UNITED STATES PATENT AND TRADEMARK OFFICE

Office Action Summary	Application No. 10/735,440	Applicant(s) KOLLMANN ET AL.	
	Examiner Charles E. Phillips	Art Unit 3751

SN 10/735,440

Replacement Sheet

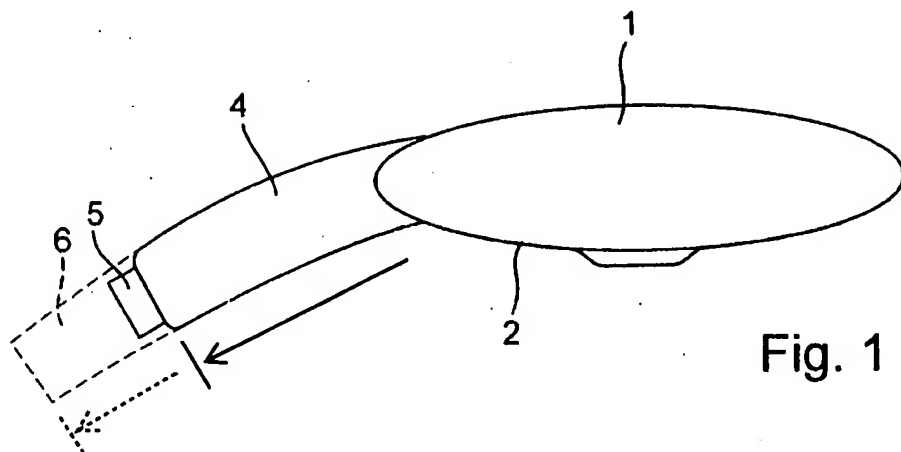
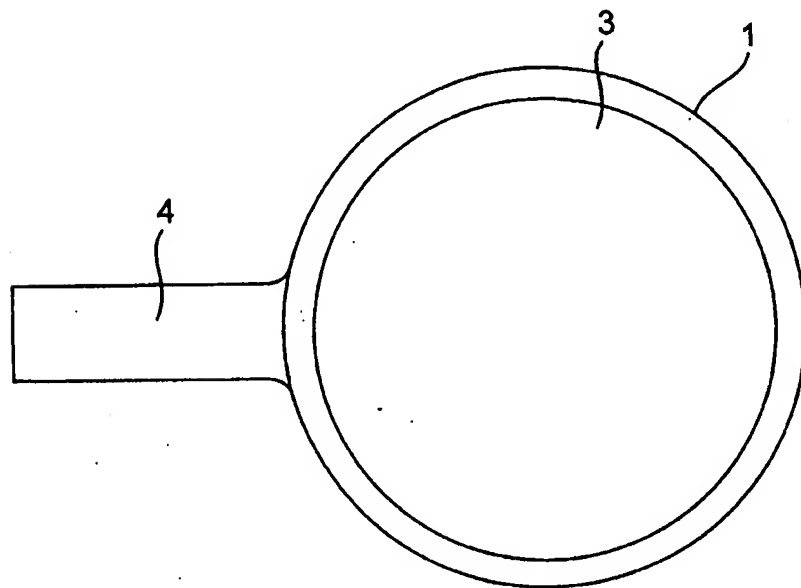
Claims 1-2 and 5-7 are rejected under 35 U.S.C. 112, first paragraph, as failing to comply with the enablement requirement. The claim(s) contains subject matter which was not described in the specification in such a way as to enable one skilled in the art to which it pertains, or with which it is most nearly connected, to make and/or use the invention. No support is found in the original disclosure for the now claimed "flush with an outer surface of the handgrip, over the longitudinal length of the union nut". The original drawings show the union nut non-formally i.e. in broken lines and in a tapered nature, as the diameter of the nut where it connects to the showerhead appears to be larger than the diameter at the opposite end. The disclosure at page 3, lines 3-11, merely states that the union nut "forms an extension of the grip" and the text at page 4, lines 16-17, merely states "its outer surface is flush with the outer surface of the handgrip". Here, "the outer surface is not defined" and the ordinary artisan could not infer from this, the meaning now claimed and argued for, particularly in light of the tapered nature shown in the original drawings.

The proposed drawing correction filed on 4/6/07 is disapproved as the depiction of the union nut is inconsistent with that of the original drawings as discussed supra.

not approved
5/22/07 C&P
